19 September 2024

RE: West Kentish Town – EIA Scoping Addendum and EIA Scoping Opinion Response (Planning Reference: 2022/5281/P)

EIA Scoping Addendum

Figure 1 Comparison of Indicative Phasing Plans

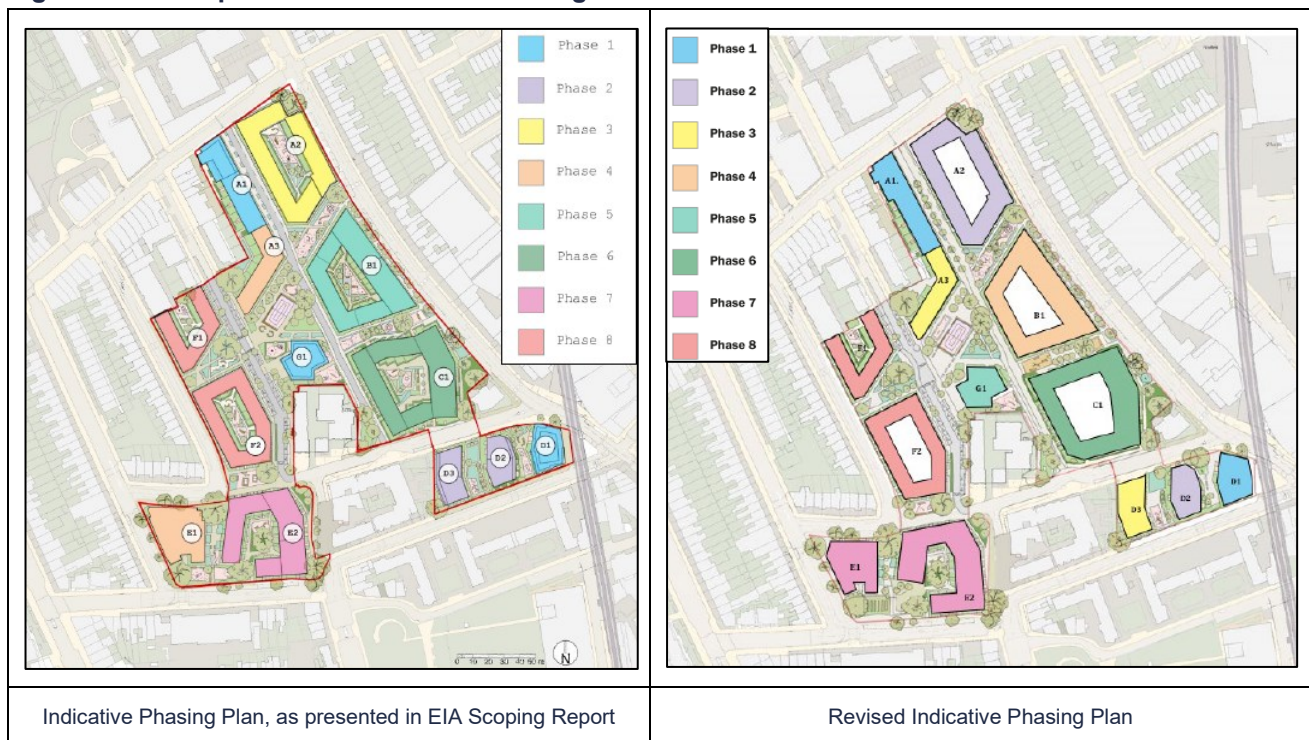
- Removal of Phase 0 to account for the earlier demolition of the garages and MUGA on site (refer to 'Baseline Conditions' for context);
- Increase in the maximum height of the Proposed Development from 50.0m to 55.00m;
- Block G1 has been moved from the detailed component to the outline component;
- The Indicative Phasing Plan for the Proposed Development has been revised with the following changes with the two different indicative phasing plans shown in Figure 1:
 - Block A2 has been moved from Phase 3 to Phase 2;
 - Block A3 has been moved from Phase 4 to Phase 3;
 - Block B1 has been moved from Phase 5 to Phase 4;
 - Block D3 has been moved from Phase 2 to Phase 3;
 - Block E1 has been moved from Phase 4 to Phase 7;
 - Block G1 has been moved from Phase 1 to Phase 5;

Figure 2 Location of Demolished Garages and MUGA

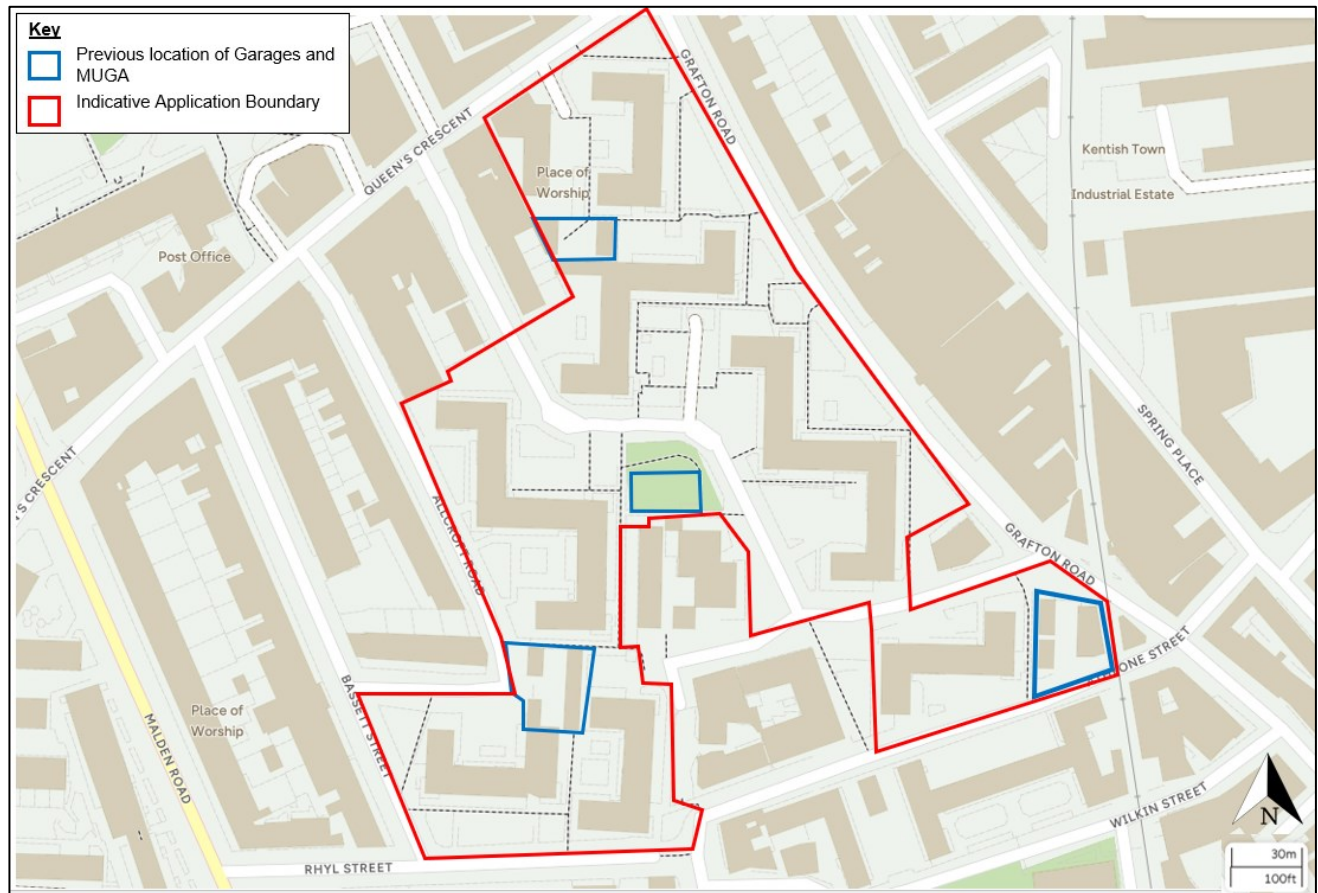
Garages located to the east of the existing Ashington Building (Block D1), to the northwest of the existing Langridge Building (Block E1) and the MUGA space at the Block G1 location have been demolished pursuant

to permitted development rights, since the submission of the EIA Scoping Report and receipt of the EIA Scoping Opinion. The location of these spaces within the site are shown in Figure 2.

As these garages and MUGA have since been demolished, it is considered that the current baseline position is with these garages/ MUGA removed and therefore, this will be treated as the baseline position within the EIA for the purposes of assessment.
